SERVICE BULLETIN MAINTENANCE OF WAY EQUIPMENT

DATE: 10-18-2001 **BULLETIN NO:** 01-014

TITLE: 198194 AXLE WASHER REPLACEMENT SERVICE GROUP

PRODUCT SERIES / MODEL: All Vehicles Equipped With HY-RAIL® Guide Wheel Equipment Series HR18, HR2000A and HR2000B

FIGURE 1 SE01A354A-1
RAIL WHEEL ASSEMBLY

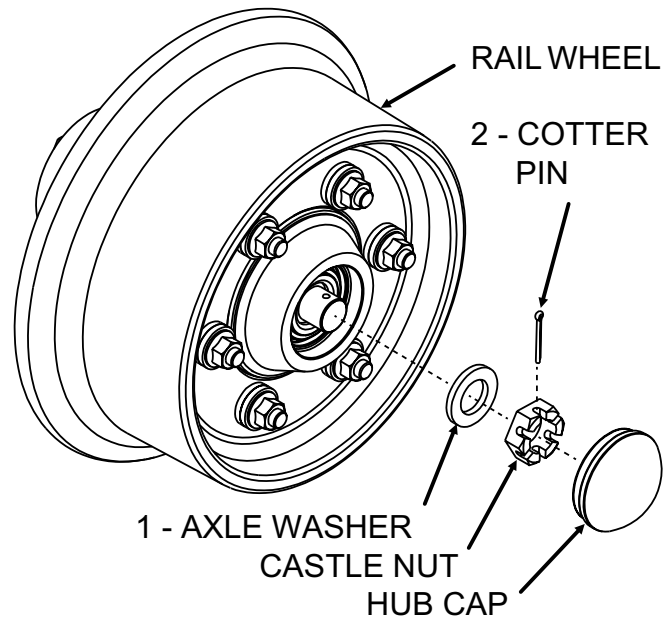
SUMMARY: The 3/32 inch thick axle washer can deform due to excess rail wheel flanging loads and cause excessive play in the rail wheel assembly. The 3/32 inch axle washer must be replaced by a 3/16 inch thick axle washer.

AXLE WASHER INSPECTION AND/OR REPLACEMENT - See Figure 1

1. Remove the hub cap from the wheel hub. Remove the cotter pin and then remove the castle nut from the spindle. Remove the existing axle washer from the spindle.
 - 2.1 If the thickness is 3/32 inch (2.38 mm), the axle washer must be replaced.
 - 2.2 If the thickness is 3/16 inch (4.76 mm), the axle washer can be re-used provided it is not deformed.
3. Install the axle washer (1) on the spindle. Install the castle nut on the spindle and torque to 20 ft-lbs. Loosen the castle nut and re-torque to 7 ft-lbs. Then back off the castle nut 1/2 to 1 flat and secure with the cotter pin (2). Install the hub cap on the wheel hub.

- Disassembly of the rail wheel to inspect and measure the existing axle washer thickness.
- If the existing axle washer thickness is 3/32 inch (2.38 mm), the axle washer must be replaced.
- If the existing axle washer thickness is 3/16 inch (4.76 mm), the axle washer can be re-used provided it is not deformed.
- Re-assembly of the rail wheel.
- Re-torquing of the spindle nut.
